Siler City
CHATHAM COUNTY
TRANSFER STATION IMPROVEMENTS.

Subject: Chatham County Transfer Facility
Permit # **19-03T**
Siler City, Chatham County, North Carolina
Modification #3

7. AMENDMENT #3(17 Feb. 2000): Letter and shop drawings dated 12 January 2000, addressing proposed upgrades to the transfer station consisting of leachate collection system, approach apron repairs, and retaining wall modifications.

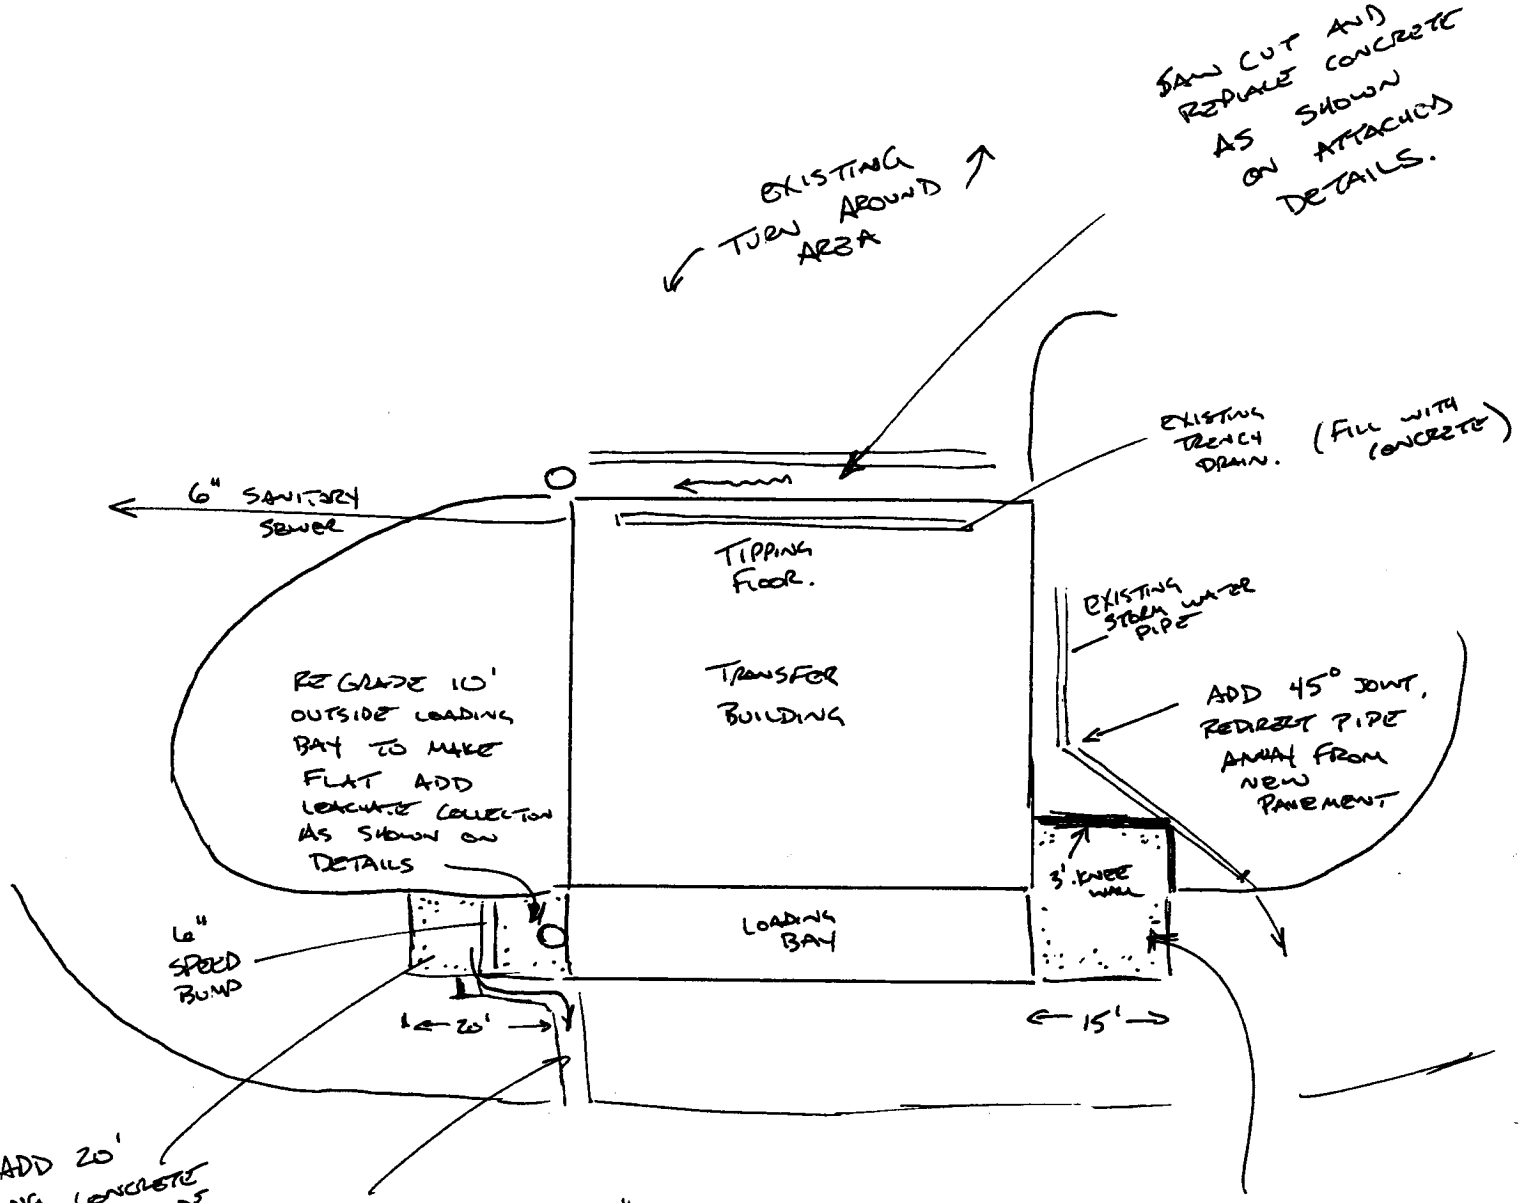
ADD 20' LONG CONCRETE APRON OUTSIDE OF LOADING BAY.

ADD 30" WIDE, 4" DEEP 6" THICK CONCRETE "V" FLUME TO DIRECT STORM WATER AWAY FROM LOADING PIT.

ADD NEW CONCRETE AND 3' KNEEWALL TO LOADING BAY EXIT. NEW CONCRETE TO BE FLUSH WITH LOADING BAY.

LOADING BAY LEACHATE COLLECTION IMPROVEMENTS.

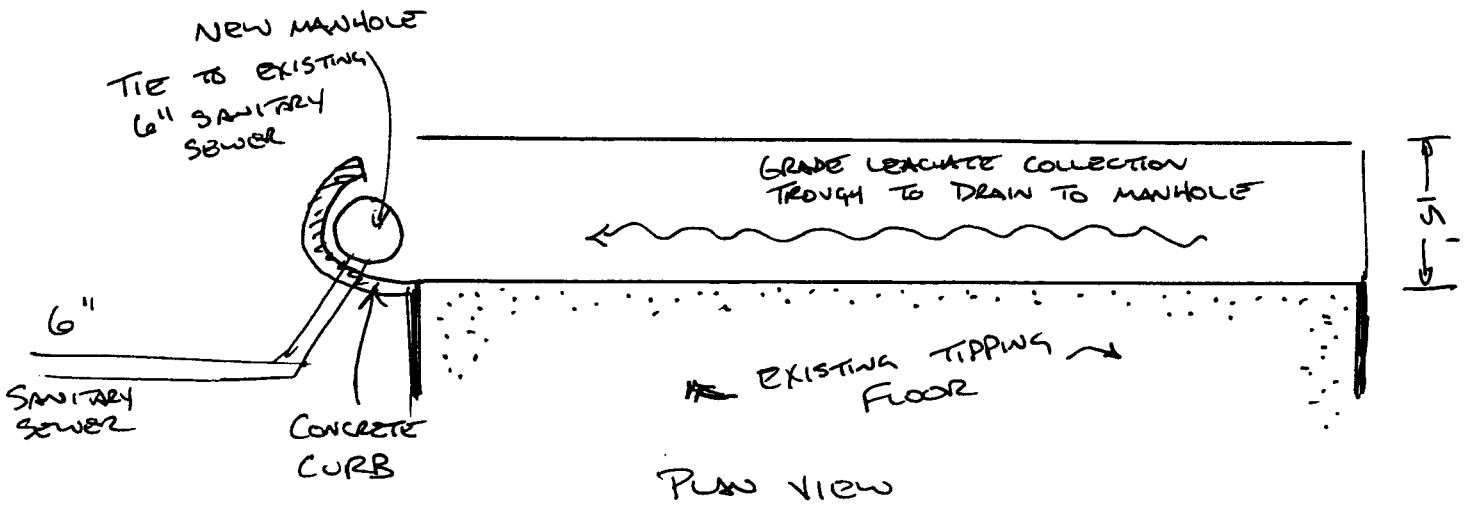
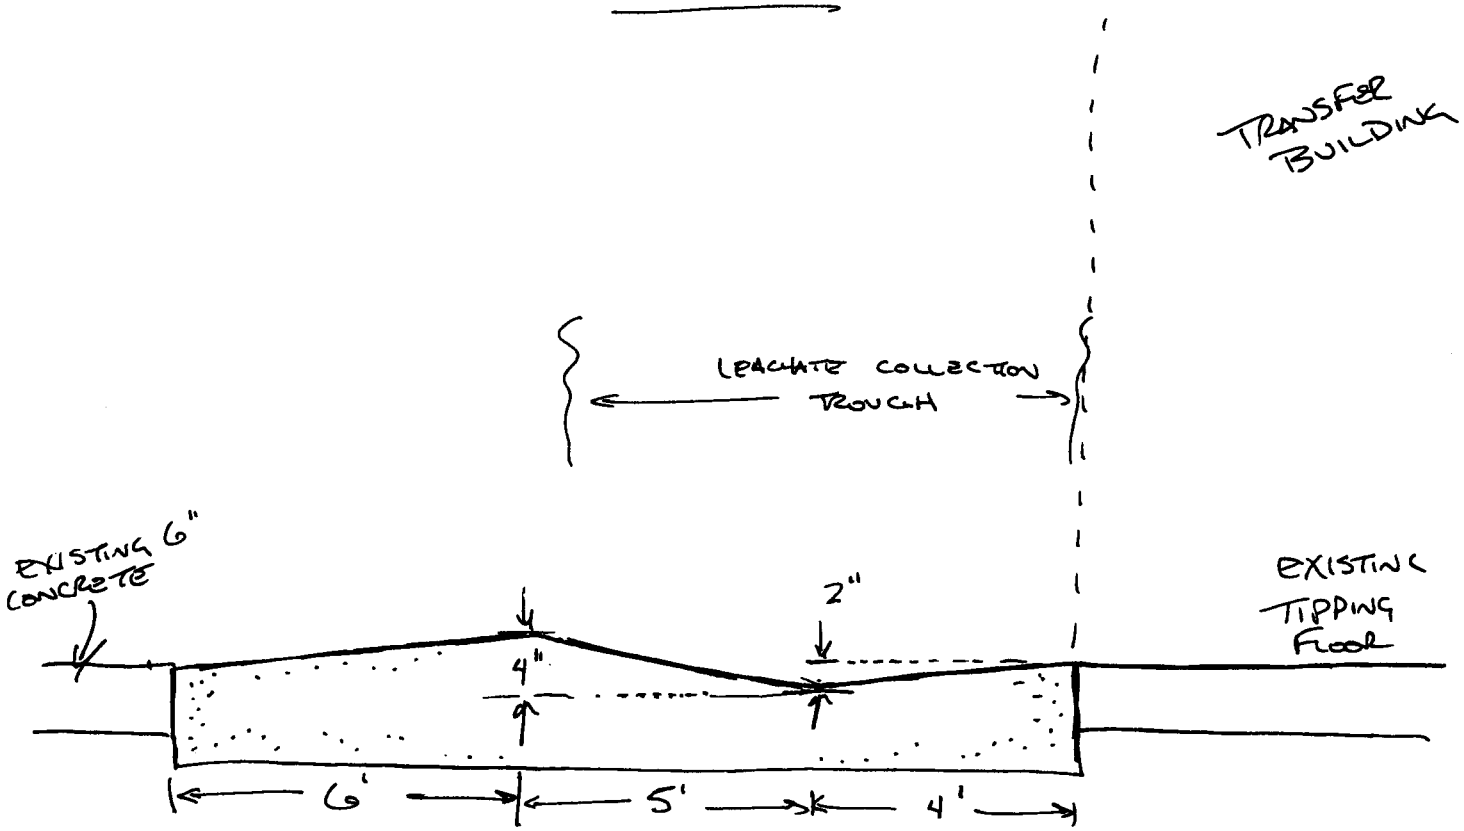
NEW CONCRETE APRON TO CONTROL LEACHATE.
MINIMUM PAVING DEPTH IS 6" USE 5000 PSI
HIGH EARLY CONCRETE WITH 6X6 WELDED WIRE

DETAIL
MANHOLE COVERS

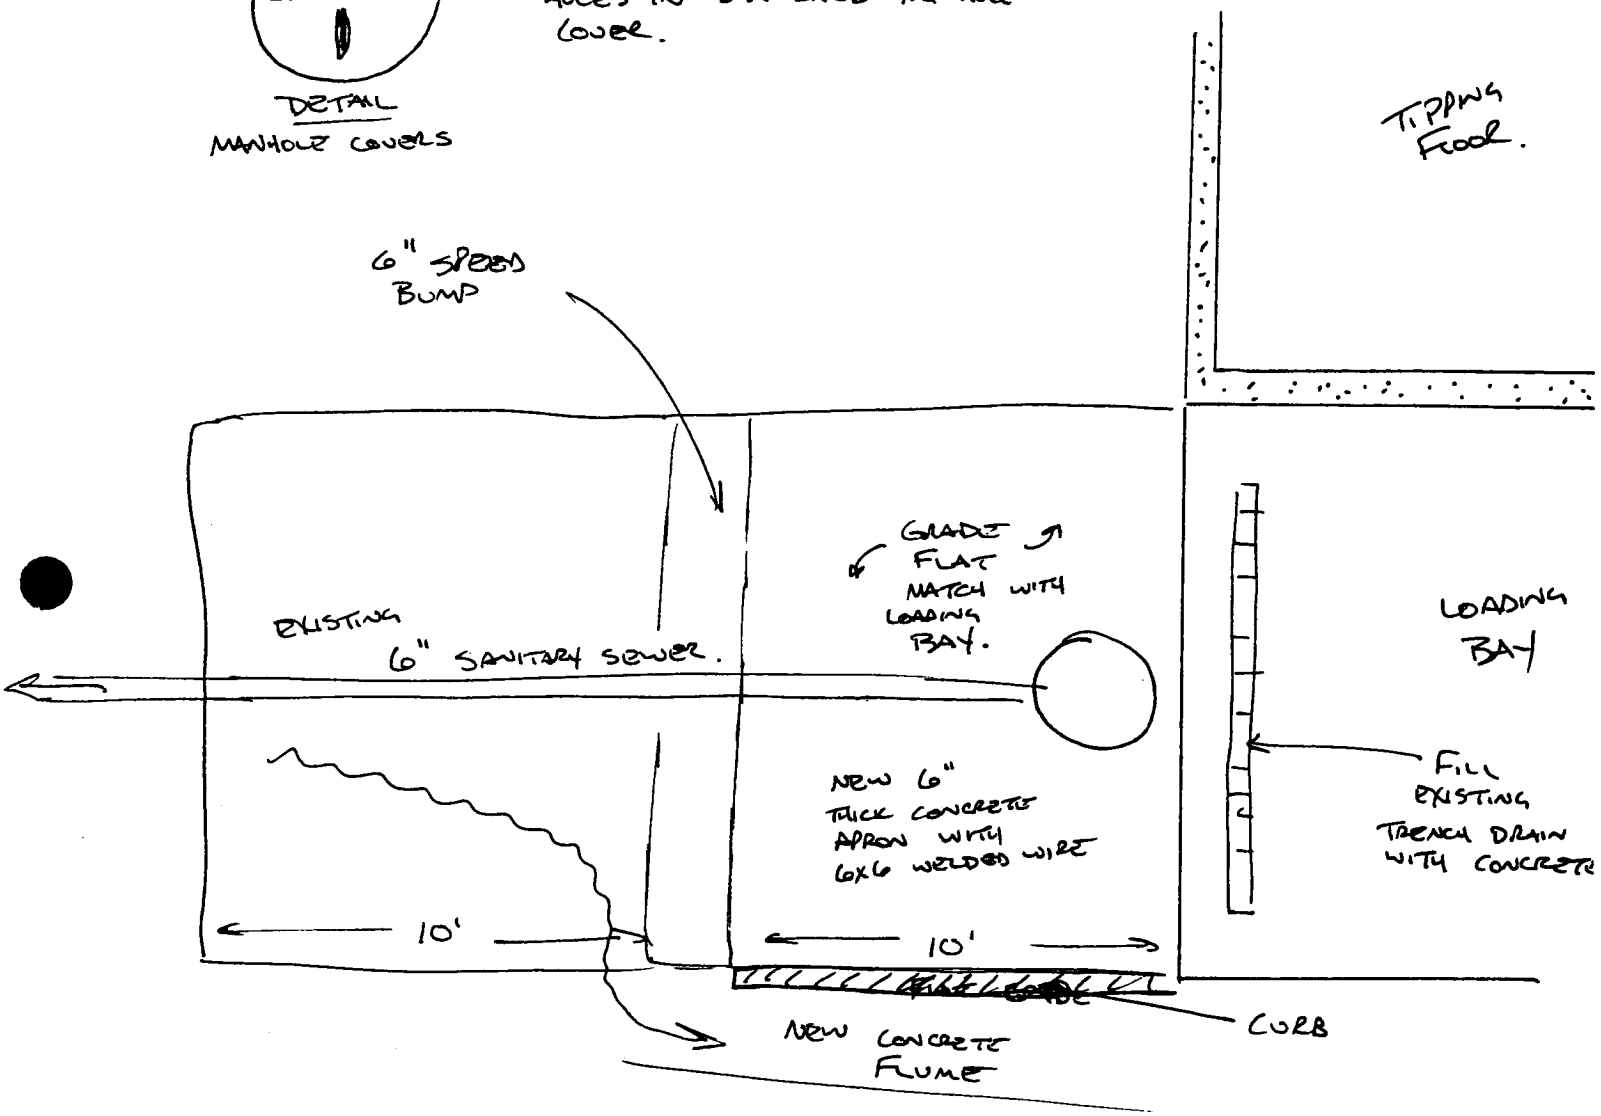
BURN ½" WIDE BY 6" LONG HOLES IN STANDARD MANHOLE COVER.

NOTES: FIELD LOCATE EXISTING SANITARY SEWER AND INSTALL 4' DIA CONCRETE MANHOLE WITH TRAFFIC RATED COVER.

SET DEPTH OF NEW MANHOLE ~~[illegible]~~ AS REQUIRED BY EXISTING SANITARY SEWER.
